Product / Process Change Notification (PCN)

<p>PCN #: PCN_IndSPC_20200423</p> <p>Affected Series: WE-SPC; 74408941xxx, 74408942xxx, 74408943xxx</p> <p>PCN Date: March 23, 2020</p> <p>Effective Date: April 23, 2020</p>	<p>Change Category:</p> <p><input type="checkbox"/> Equipment / Location <input checked="" type="checkbox"/> General Data <input type="checkbox"/> Material <input type="checkbox"/> Process <input type="checkbox"/> Product Design <input type="checkbox"/> Shipping / Packaging <input type="checkbox"/> Supplier <input type="checkbox"/> Software</p>
<p>Contact: Product Management</p> <p>Phone: +49 (0) 7942 - 945 5001</p> <p>Fax: +49 (0) 7942 - 945 5179</p> <p>E-Mail: pcn.eisos@we-online.com</p>	<p>Data Sheet Change:</p> <p><input checked="" type="checkbox"/> Yes <input type="checkbox"/> No</p> <p>Attachment:</p> <p><input type="checkbox"/> Yes <input checked="" type="checkbox"/> No</p>

Because of a database mismatch, Würth Elektronik will correct the datasheet product drawing for the whole WE-SPC series.

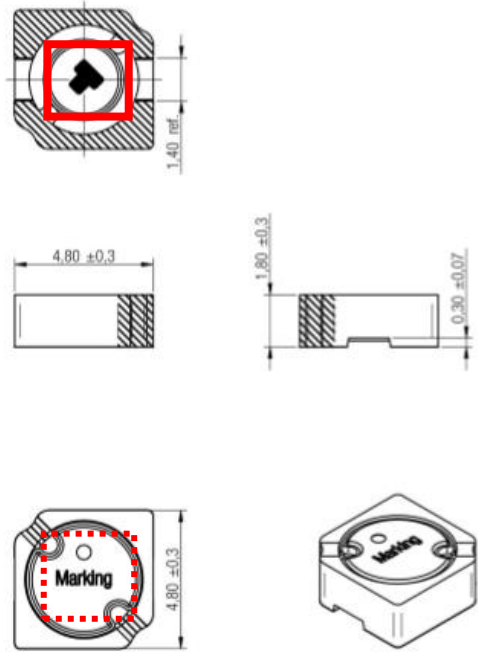
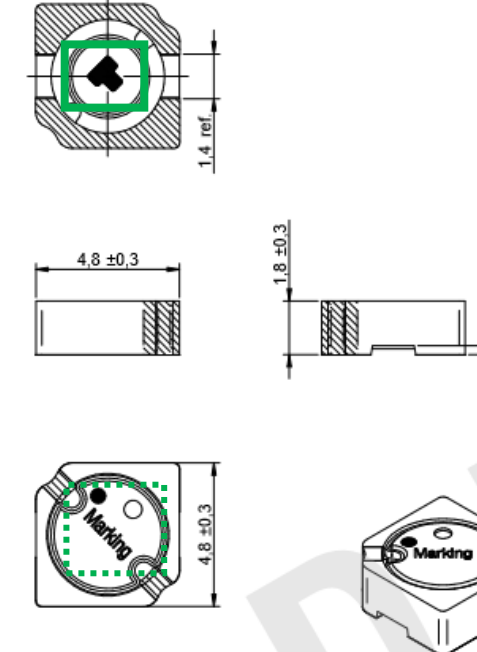
•	Start of winding										
Marking	1R0 (Inductance Code)										
Start of Winding	•										
Marking	1R0 (Inductance Code)										
<p>Summary of the corrected errors are marked with red color.</p>	<p>The position of the T will be corrected. The position of the marking will be corrected. The position of the start of winding point will be corrected (filled circle). Added the round notch on the core, this notch is only used to place the core correctly during the manufacturing process.</p>
